FINAL ALTERNATIVES ASSESSMENT  
FOR OTHER CONTAMINATION SOURCES  
INTERIM RESPONSE ACTION  
RAIL CLASSIFICATION YARD, RMA

Prepared by  
MK-Environmental Services  
Denver, Colorado 80203

October 1989

RESPONSES TO EPA COMMENTS ON THE ALTERNATIVE ASSESSMENT  
FOR OTHER CONTAMINATION SOURCES, INTERIM RESPONSE ACTION  
FOR THE RAIL CLASSIFICATION YARD, DRAFT FINAL REPORT

Figure: A-7

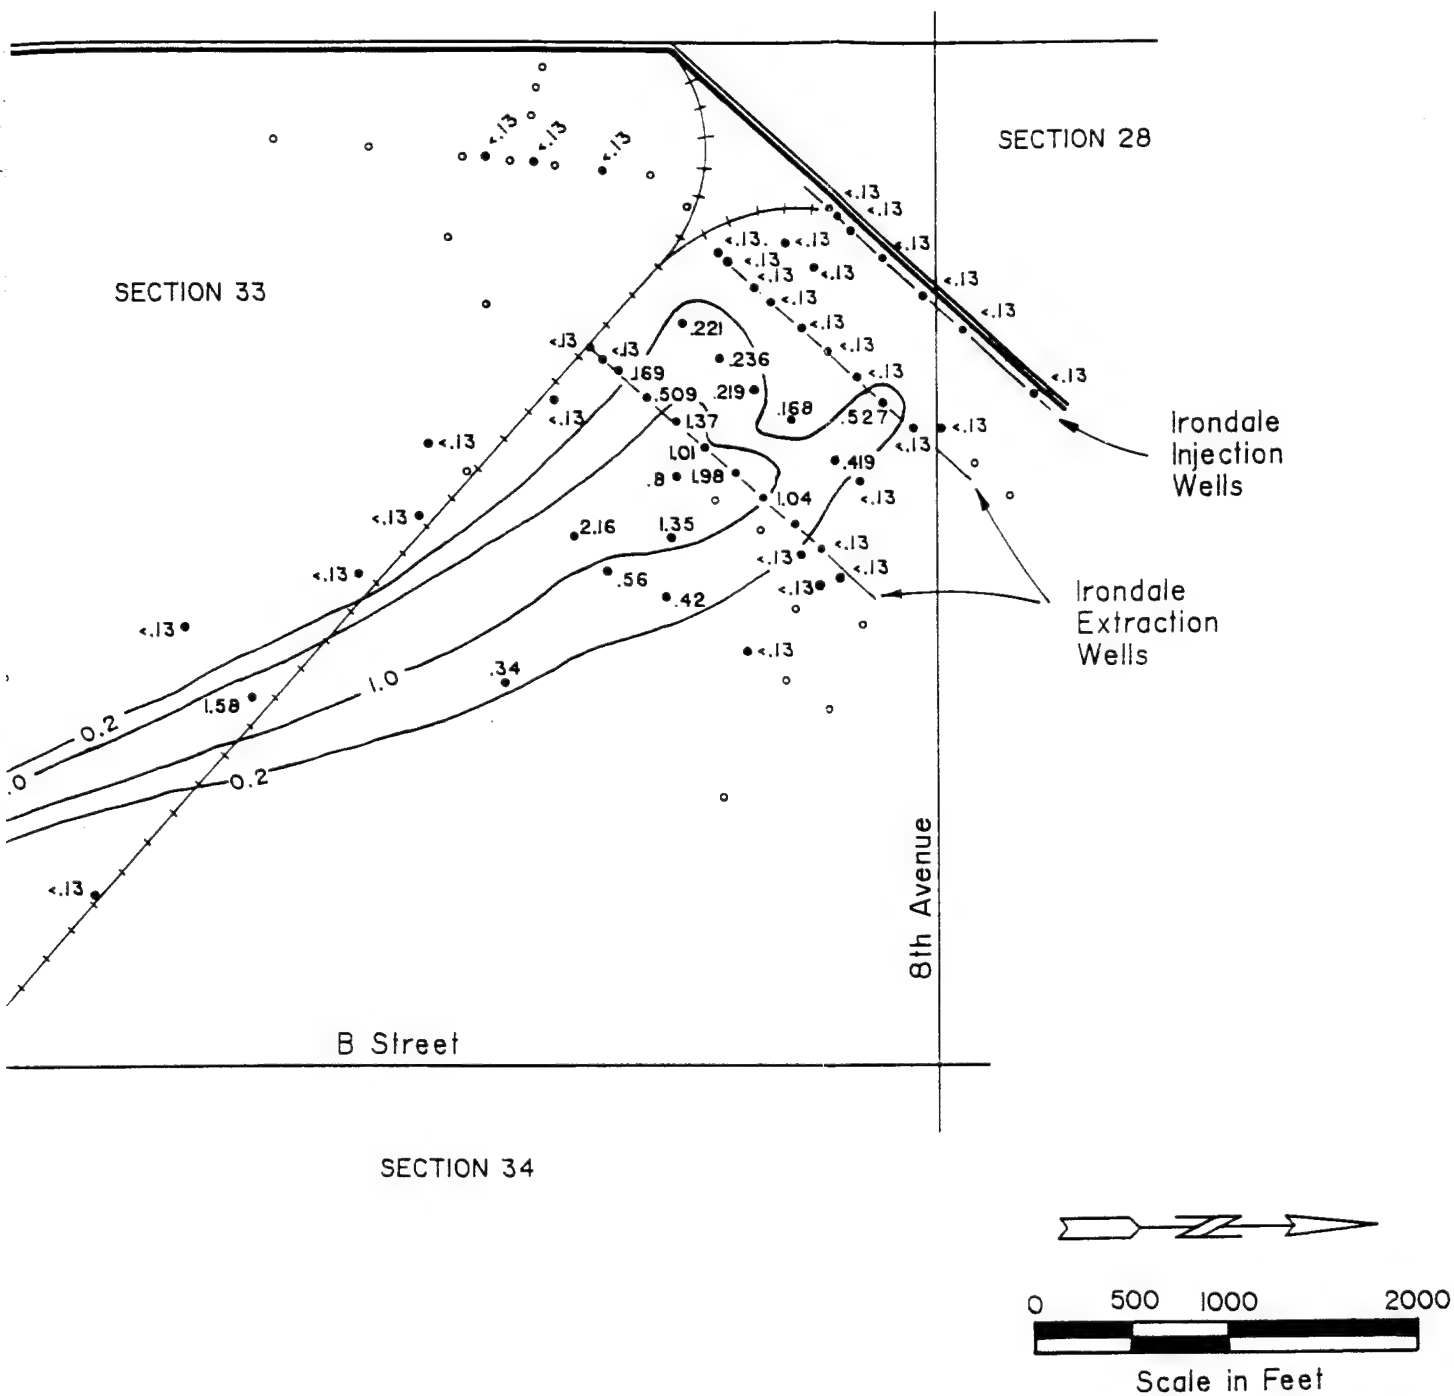
Page 9, Section 5.2, Groundwater Interception/Containment, the text states that DBCP is the only contaminant of concern in the railyard area groundwater. However, the maps presented in the Comprehensive Monitoring Program (CMP) Annual Groundwater Report for 1988 indicate that a chloroform plume exists in the railyard area, and that the railyard could be the source of the chloroform plume. Please consider whether treatment of the chloroform plume could also occur.

The distribution of chloroform in groundwater in the railyard area is erratic and a plume is not defined. The highest

concentration of chloroform detected in the groundwater was 18 ug/l (WSAR). The ARAR for chloroform is 100 ug/l. Treatment of the groundwater to remove chloroform does not appear to be necessary. Please see the response to Comment 1 for additional details.

Figure: A-8

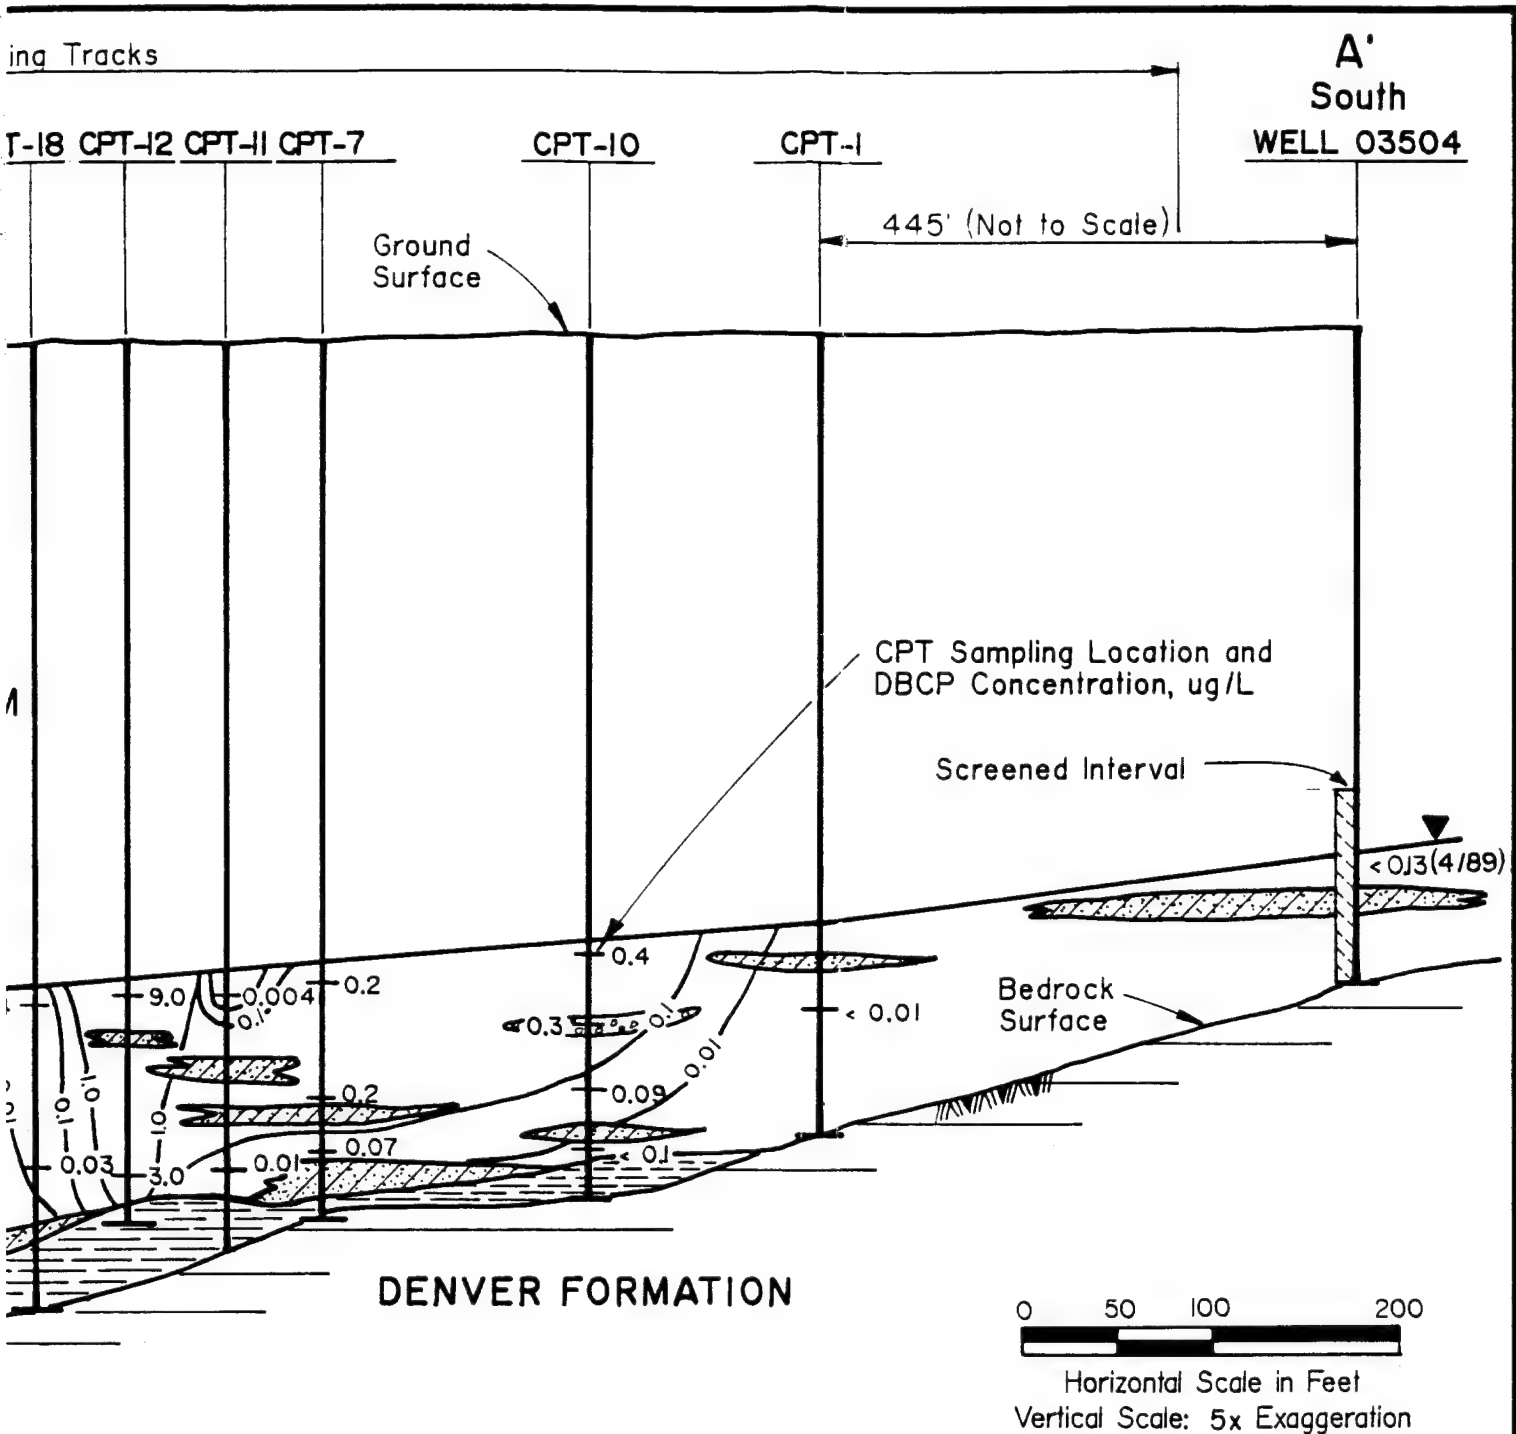
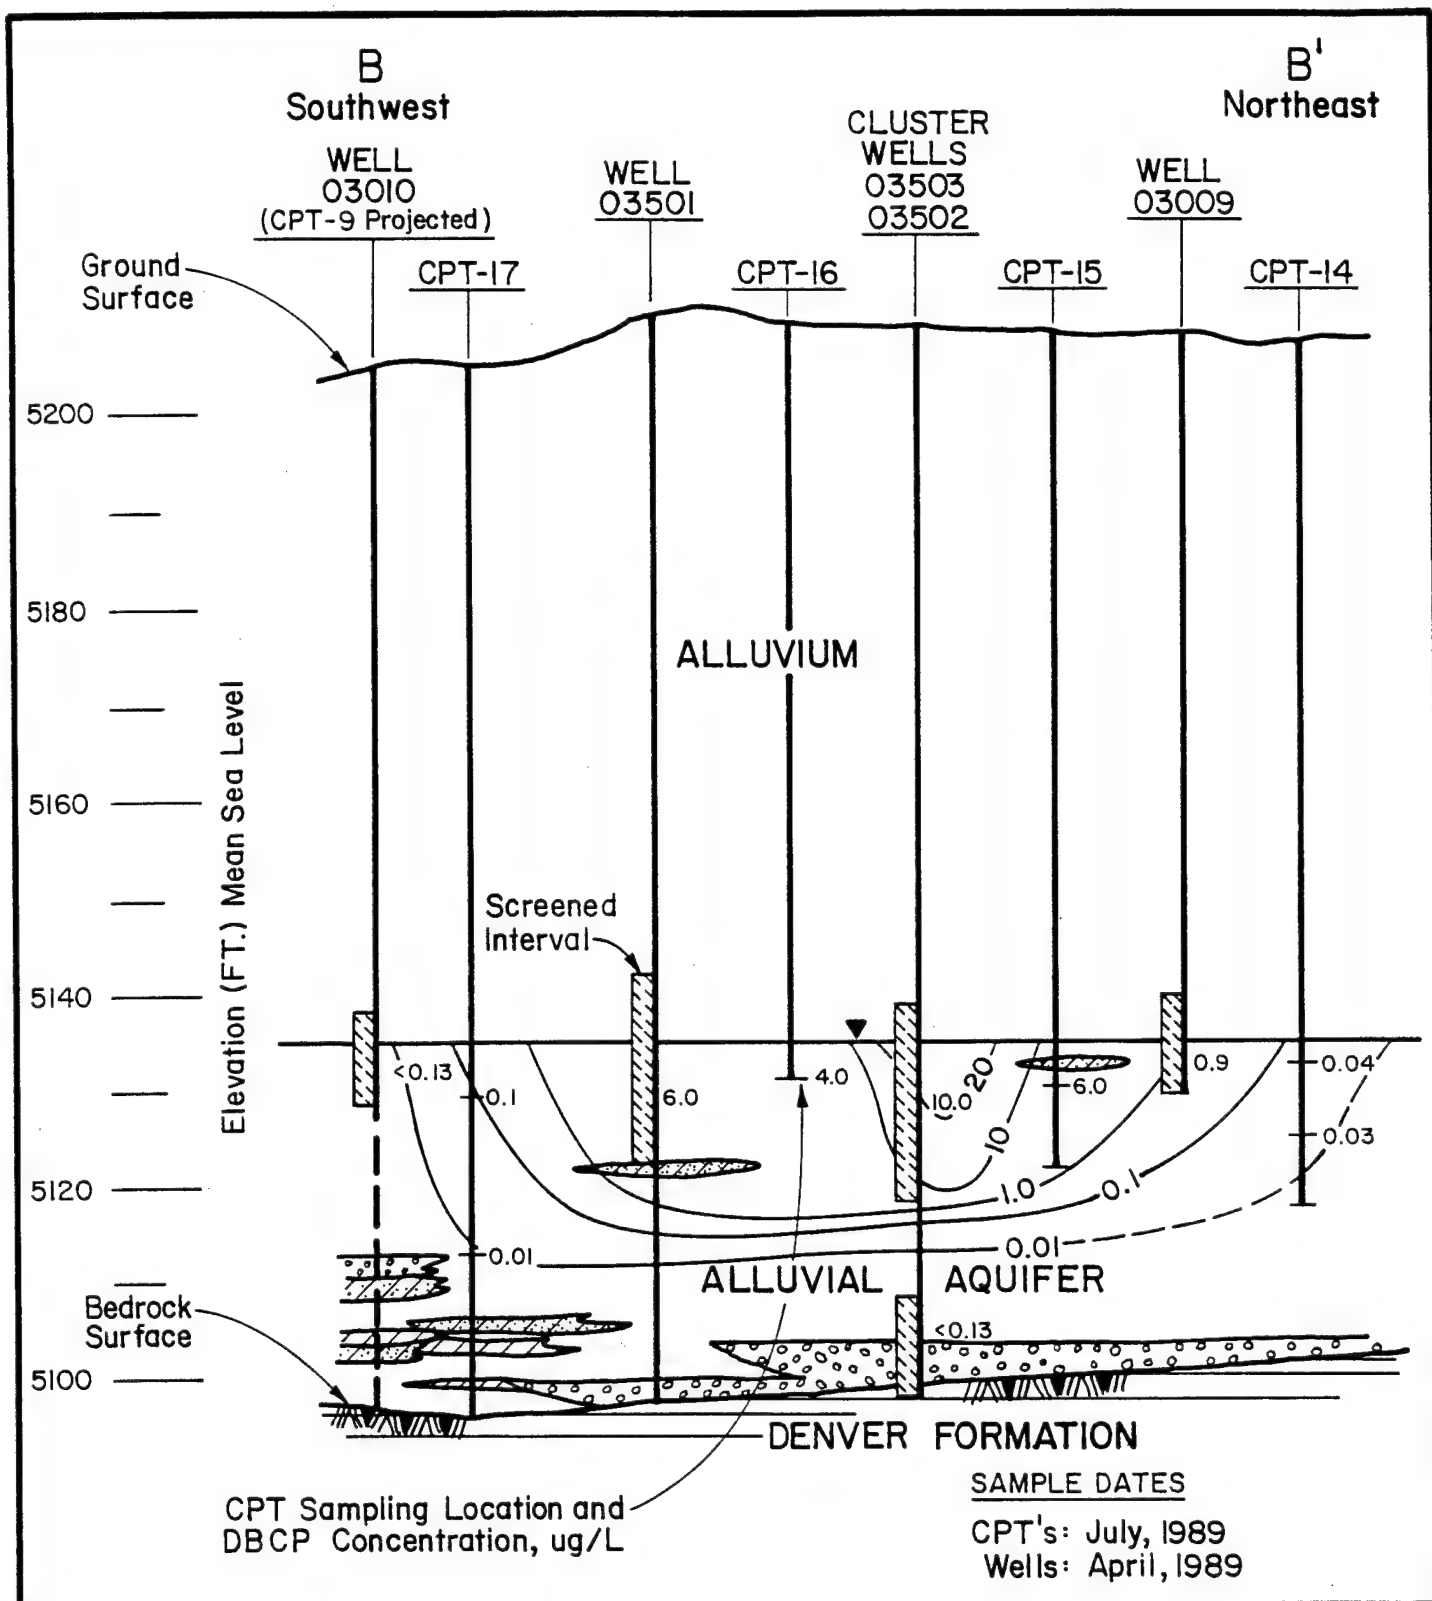
Page 9, Section 4.4, second paragraph, please expand the text to explain the statements that the concentration of DBCP in groundwater consistently decreases with depth. Please expand the basis for this statement and the assessment made to confirm this statement.

Section 4.0 of the Alternative Assessment Document is a summary of the railyard site characterization. A more detailed description of the results of the site investigation is included as Appendix A. Within Appendix A, groundwater quality and vertical distribution of DBCP in the alluvial aquifer are discussed in Section 2.3, beginning on Page A-10. The groundwater quality data are listed in Tables A-3 and A-4, and the vertical distribution of DBCP is illustrated in Figures A-8 and A-9.

Groundwater samples were collected from more than one depth in eleven of the CPT borings in order to investigate the vertical distribution of DBCP. Typically, one sample was collected from the upper two feet of the saturated zone, and one was collected from the lowermost permeable zone above the Denver Formation bedrock. The DBCP concentration decreased with depth in the aquifer in eight of the eleven CPT locations and in the 2-well cluster (Wells 03502 and 03503) located within the plume.
